City of Brisbane

Planning Commission Agenda Report

SUBJECT: **60 Plumas Street;** Design Permit DP-2-13; Design Permit for Development of a Three Unit Multi-family Dwelling on a 5,000 sq ft Vacant Lot in the R-3 Residential Zoning District; James Seto, applicant; James, Saovanh, Robert, and Amy Seto, owners; APN 007-223-010

CONCEPTUAL LANDSCAPE PLAN

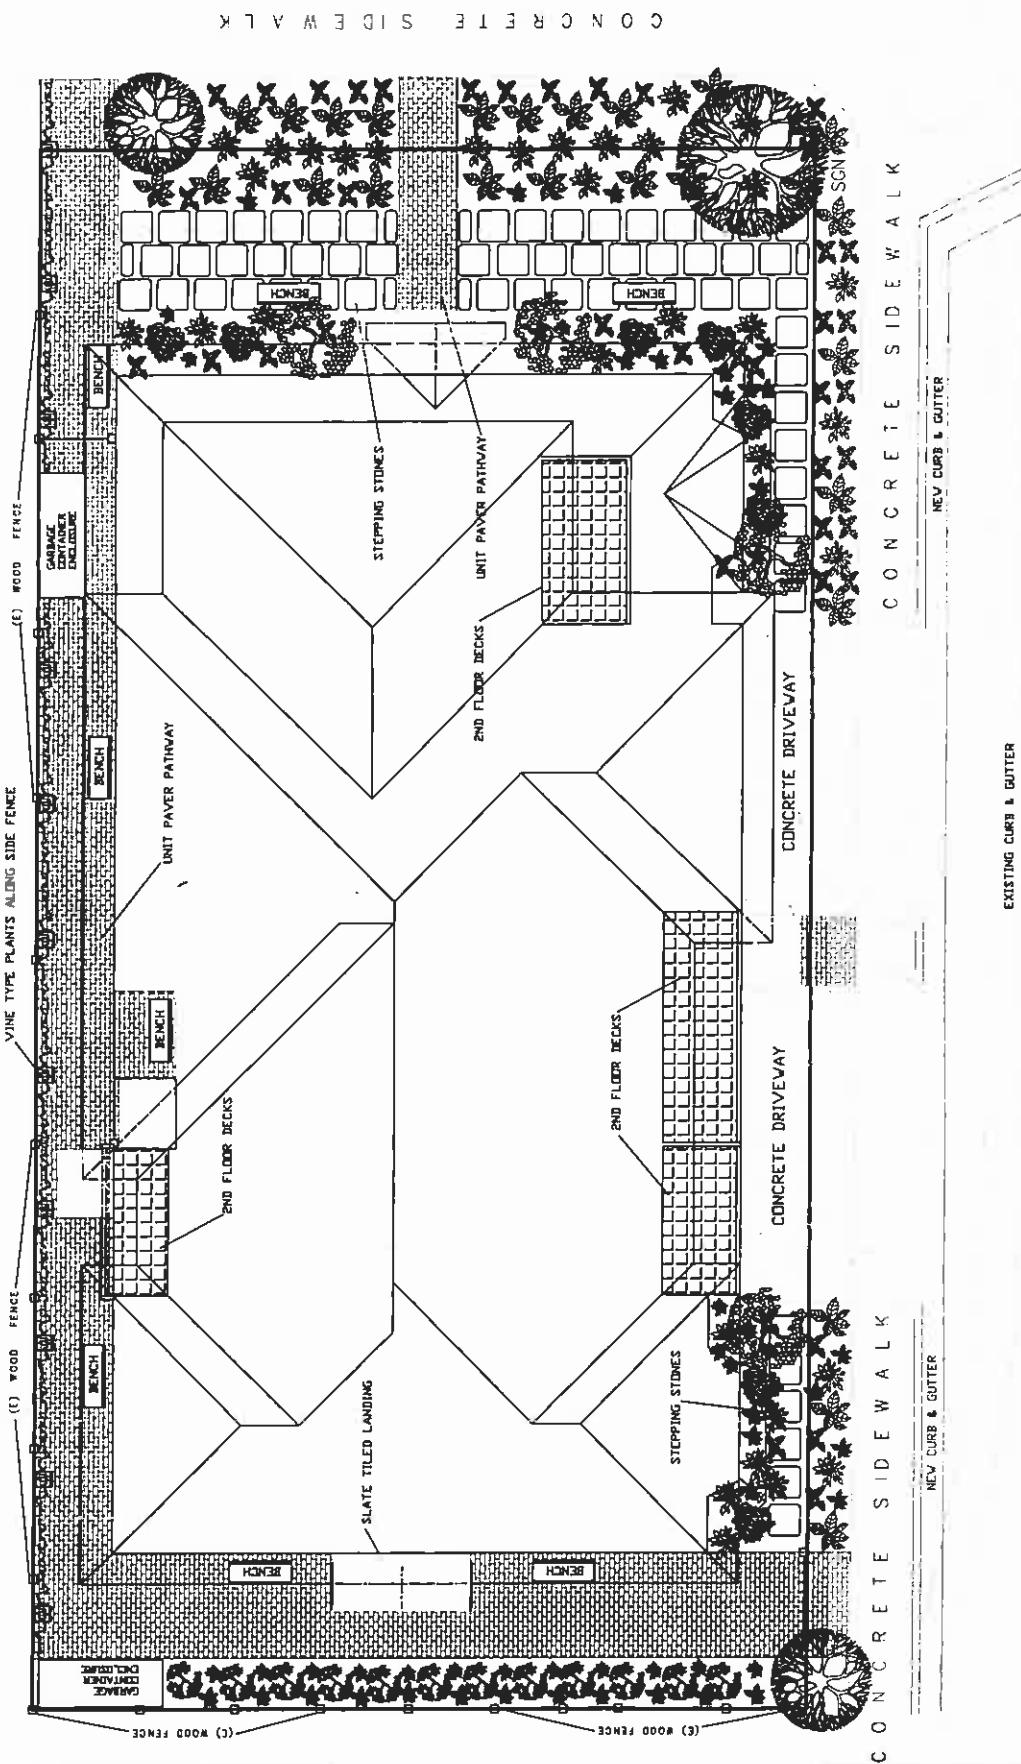
6. The plans submitted for a Building Permit shall be revised to correct sheet L2 to show the required:
 - Minimum setback of 12 ft for front entry canopy and 7 ft for the rear entry canopy;

- Minimum 15 ft building setback for the front of the building
7. The design and specifications on the benches shall be provided as part of the final landscape plan, for Community Development Director approval. Benches are to be adequately weighted or attached to the ground to discourage theft.
